**ADDENDA 1**

To: All Interested Vendors  
From: Blanca Güereca, Procurement Data Analyst  
Date: November 1, 2018  
Subject: Bid 19-006, Vista Del Este Water Distribution System

**FIRE HYDRANT INSTALLATION  
(INSIDE PARKING LOT)**

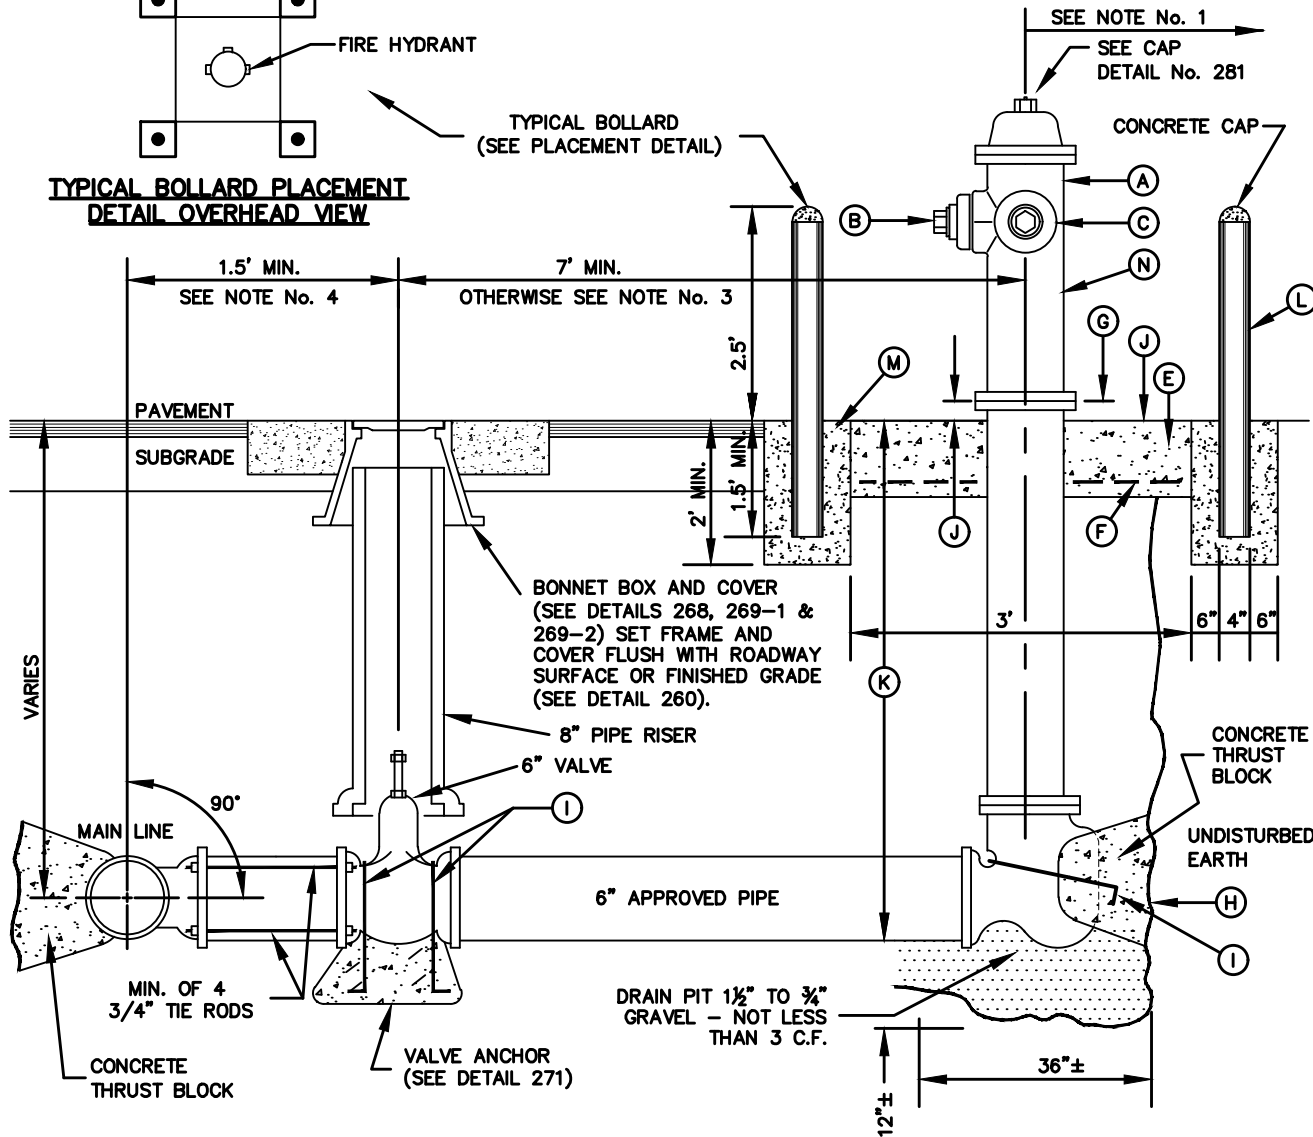
14. Item 10 on the Bid Price Sheet calls for installation of Fire Hydrant, complete with appurtenances, how many bollards per hydrant are you going to require?

**RESPONSE: A minimum of two bollards per fire hydrant are required. Shall comply with El Paso Water Fire hydrant installation (Inside parking lot) detail 280-3 standards. The two pipe bollards closest to the roadway are required the back two bollards are not. (See attached file)**
